Re: Planning Application 253074

Application for approval of **Reserved Matters** pursuant to Outline Planning Consent 230074 (allowed at appeal APP/X0360/W/24/3342812) for the erection of 23 dwellings with associated access and 15 carparking spaces for the local primary school. Details of appearance, landscaping, layout and scale to be considered.

I wish to OBJECT to this application for the following reasons:

Figure 3 Showing Very Poor Condition of EA assets in Hurst proposed drainage strategy for site is reliant upon.

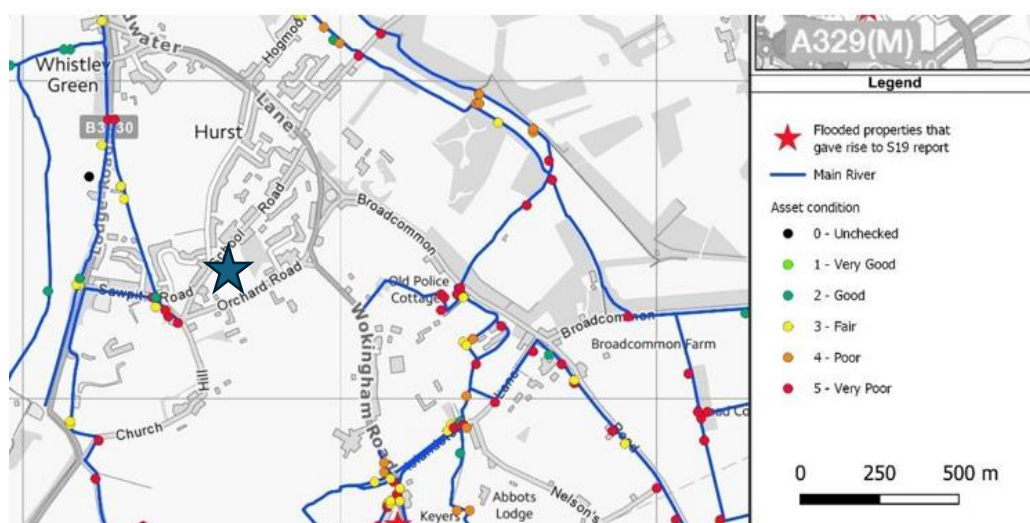
- The Drainage Strategy Report has not taken into account that the WBC S19 Flood Investigation Report 2024 highlighted that **Hurst has Very Poor EA and privately owned drainage assets at the**

Junction of School Road, Sawpit Road, Church Hill (not Church Road as indicated by the RCD Drainage Strategy Report) **and Orchard Road** (See Figures 3 and 4).

It is highly likely that the proposed surface water runoff soakaways, together with the high ground water table will be **inadequate once every three years** and the SuDS will be reliant on the surplus runoff to be dealt with by inadequate Assets. Subsequently this will exacerbate the flooding already present in the surrounding areas.
